ADDENDUM NO. 1

August 7, 2026

Parking Lot Expansion

Upper Valley Career Center
8811 Career Drive
Piqua, Ohio 45356

DRAWING NUMBER
E2.0

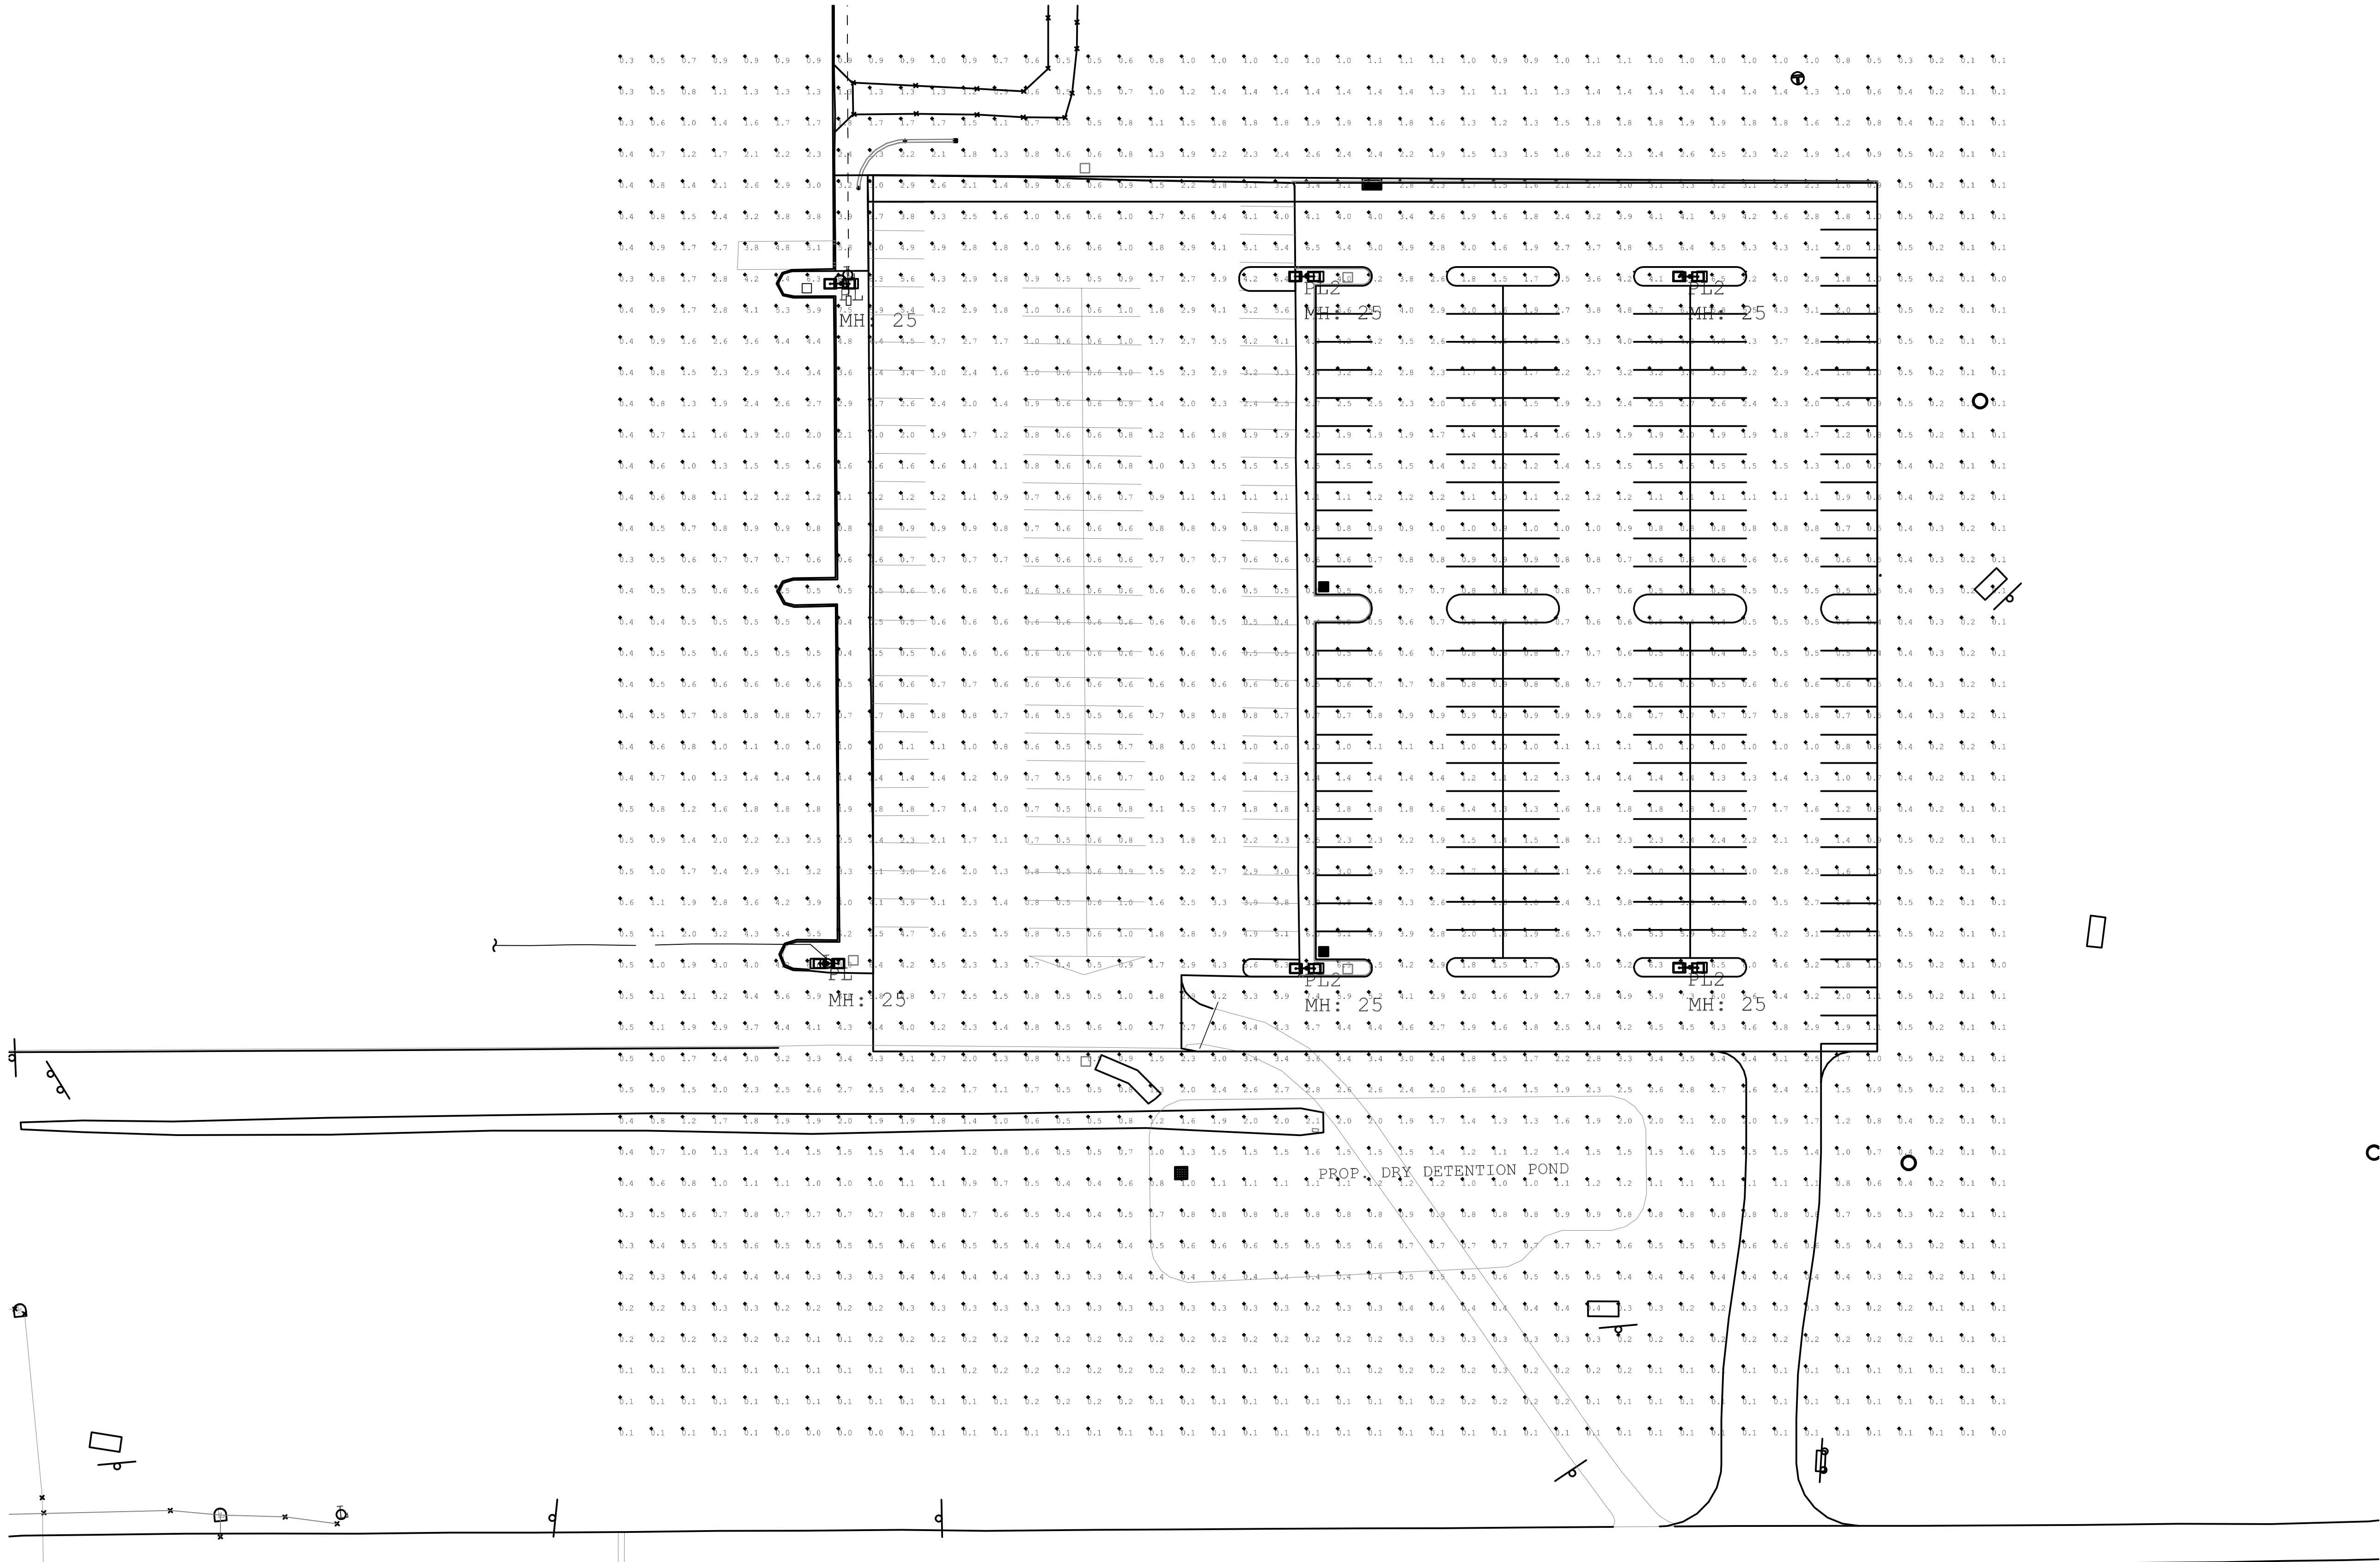
- 5.1 Drawing E0.1 – In 'Lighting Fixture Schedule' revise parking lot lighting fixture model specification; and revise poles from aluminum to steel. Refer to drawing issued with Addendum.
- 5.2 Drawing E1.0 – Revise "Underground Duct' Detail A to revise all underground conduit encasement from concrete to sand. Revise 'Typical Pole Base Detail – Raised' Detail B to allow option of precast bases. Refer to drawing issue with Addendum.
- 5.3 Drawing E2.0 – New drawing issued with this Addendum with Parking Lot Lighting Photometrics; for Permit use only.
